*In Re: Narragansett Bay Commission
Docket No. 4944*

Attached please find the revised plans from Waterman Engineering which have incorporated all the revisions requested by the Division's consultant, Pare Corporation, with one exception related to bullet point 8 under Summary of Findings of Pare Corporation's August 6, 2019 Memorandum. Providence & Worcester Railroad, recommended against the proposed requirement as it is non-standard equipment. Pare Corporation was provided with the revised plans on August 23, 2019 and the Division was provided with a copy on August 27, 2019. On August 29, 2019, Kevin Viveiros, Vice President of Pare Corporation stated in an email that Pare Corporation had "no objection to the modification/suggestions G&W/P&W make to the plans", a copy of said email is attached hereto and incorporated by reference herein.

SHIPYARD ST. & NEW YORK AVE. CROSSING

SHIPYARD STREET & NEW YORK AVENUE
PROVIDENCE, RHODE ISLAND
JULY 2019
REVISED: AUGUST 2019

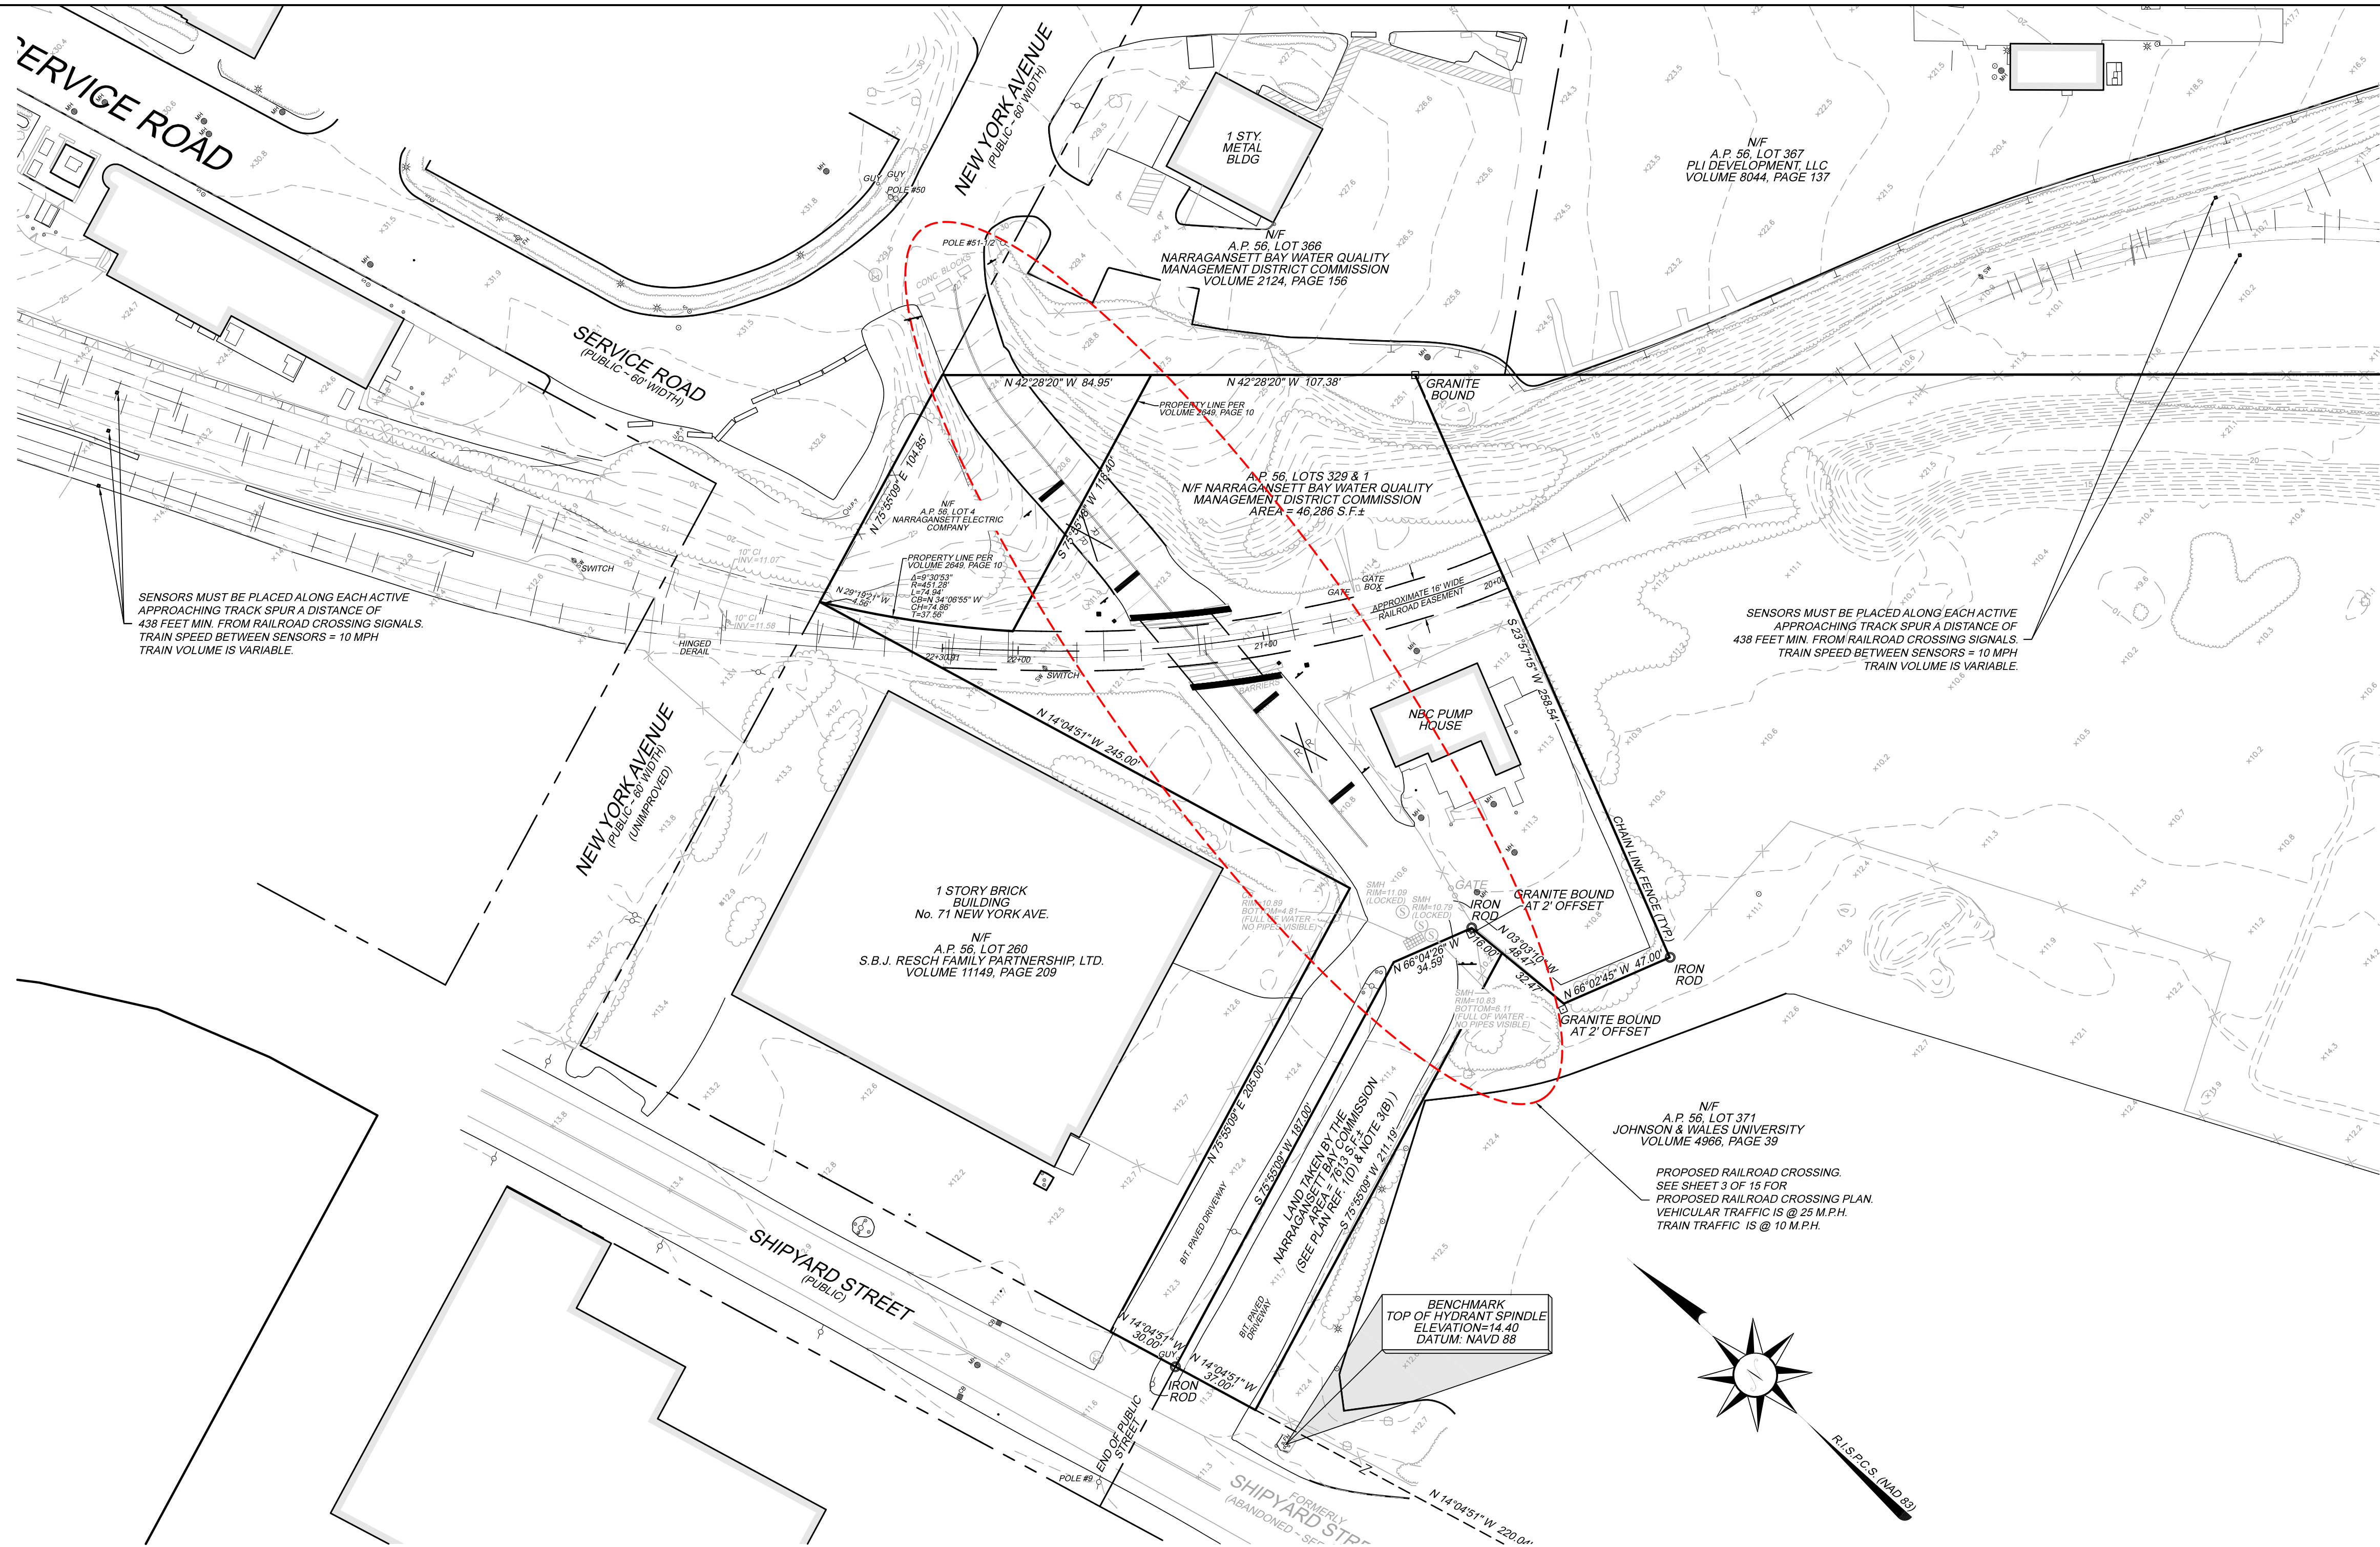
As we discussed, Chad will require stormwater management design at the northerly side of the crossing to keep the flow of water down the step driveway off of the crossing.

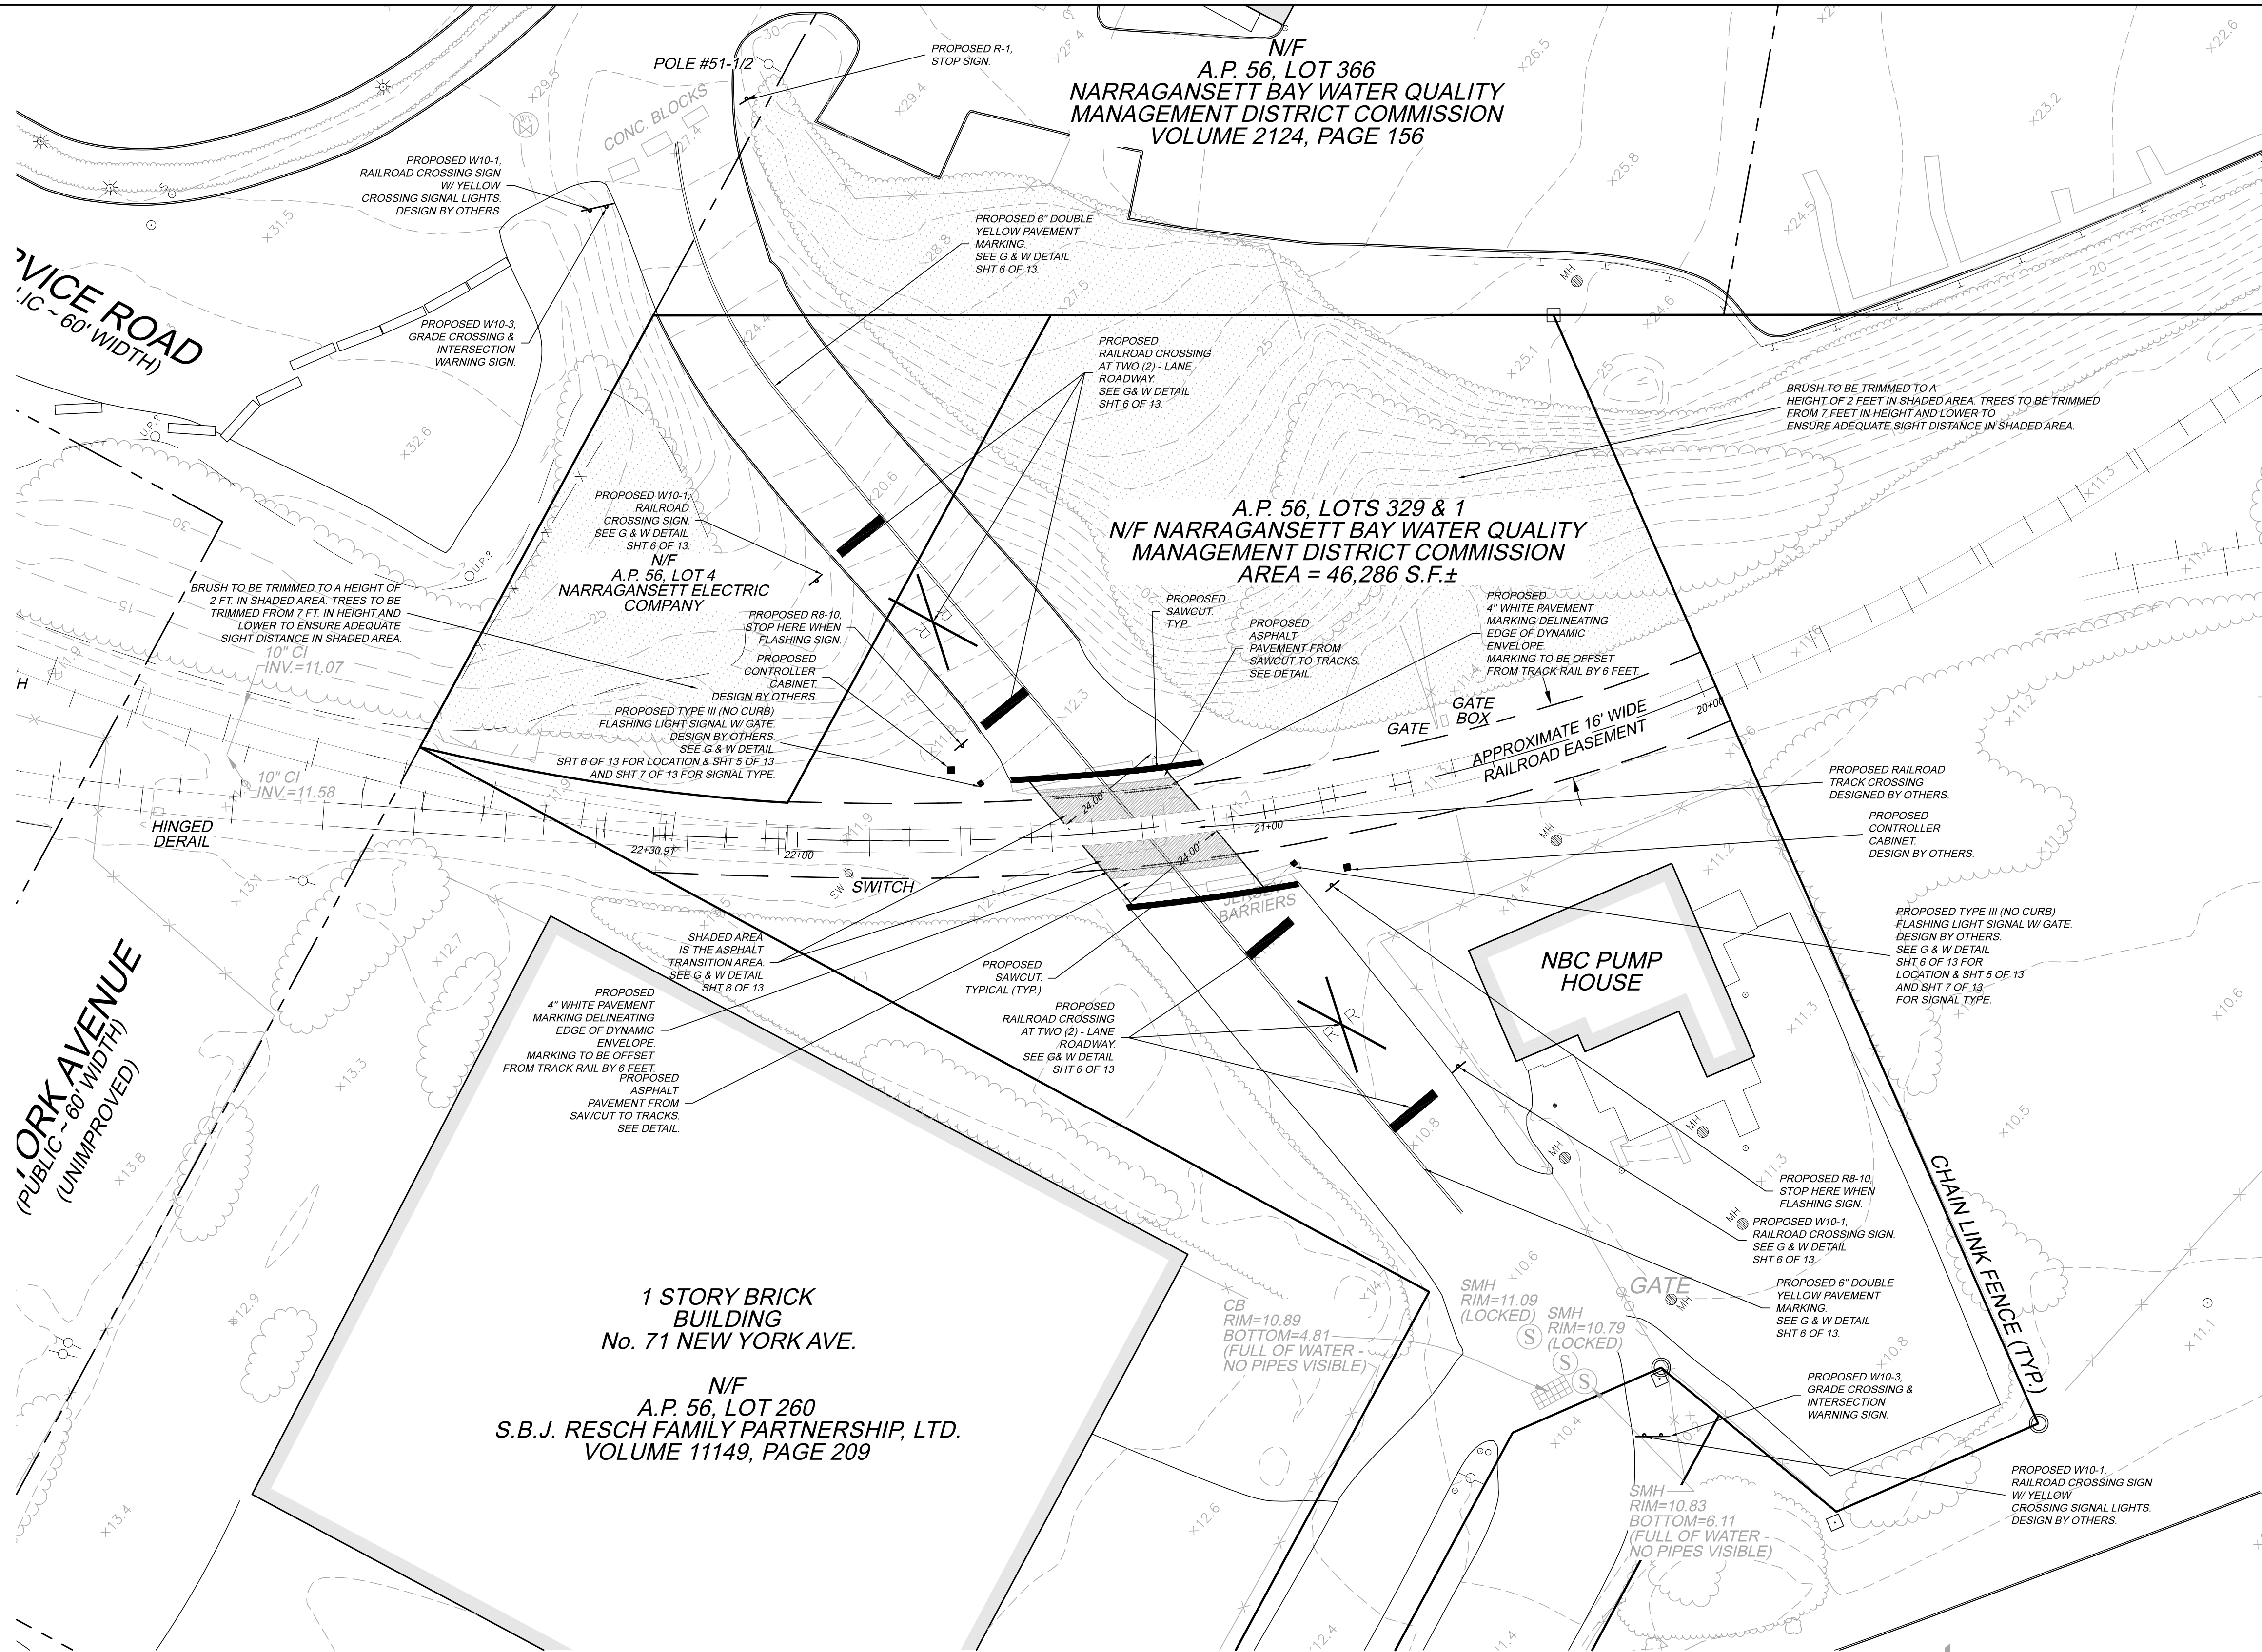
Bullet point #3, Chad Boutet who is G&W's engineering consultant is looking into the FTP-38 sign and if it is needed. We will revised per his recommendation when we receive it.

Bullet point #8, Chad has indicated that he recommends a W10-1 sign with amber flashing lights that are activated with the crossing warning devices. We have revised the plan to include this rather than the W10-3 recommended by Pare. Amy do you concur with this?
